Access Compliance Report

Public Rights-of-Way

Intersection ID: 11963	Main Street: S_GRAHAM_ST	Cross Street: W_4TH_ST	Location: E
ADA ID: 5B5FC3CD541D	Ramp Type: Perp	Initial Pass/Fail: Fail	Overall Compliance: No
		Severity Score: 8.75

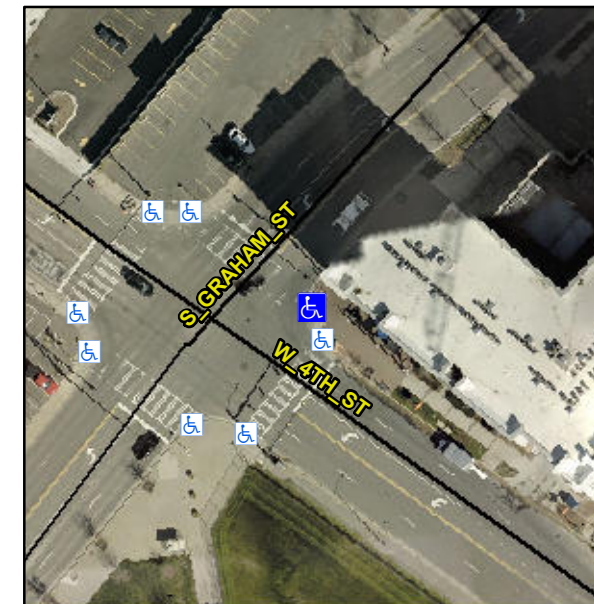
R304.5.1

Compliance	Description	Data	Compliance	Description	Data
N/A	Ramp Length (in)	72.0	Yes	Ramp Slope (%)	8.1
No	Ramp Width (in)	47.0	Yes	Ramp XSlope (%)	0.9
N/A	Flare Type LT	N/A	N/A	Flare Type RT	N/A
N/A	Flare Slope LT (%)	N/A	N/A	Flare Slope RT (%)	N/A
N/A	Flare Traversable LT?	N/A	N/A	Flare Traversable RT?	N/A
N/A	Landing Length (in)	N/A	N/A	DWS Provided?	N/A
N/A	Landing Width (in)	N/A	N/A	DWS Contrast?	N/A
N/A	Landing Slope (%)	N/A	N/A	DWS Length (in)	N/A
N/A	Landing X Slope (%)	N/A	N/A	DWS Full Width?	N/A
N/A	Landing Curb? (Y/N)	N/A	N/A	DWS Offset (in)	N/A
N/A	Shared Landing?	N/A			
N/A	Gutter Ponding?	N/A	N/A	Gutter Slope (%)	N/A
N/A	Gutter Lip Ht (in)	N/A	N/A	Gutter X Slope (%)	N/A
N/A	Painted X Walk1?	Yes	N/A	Painted X Walk2?	N/A
	X Walk 1 Direction	To NW		X Walk 2 Direction	N/A
N/A	X Walk 1 Width (in)	169.0	N/A	X Walk 2 Width (in)	N/A
	X Walk 1 Slope (%)	0.1		X Walk 2 Slope (%)	N/A
	X Walk 1 X Slope (%)	0.6		X Walk 2 X Slope (%)	N/A

Remove & Replace Entire Ramp.
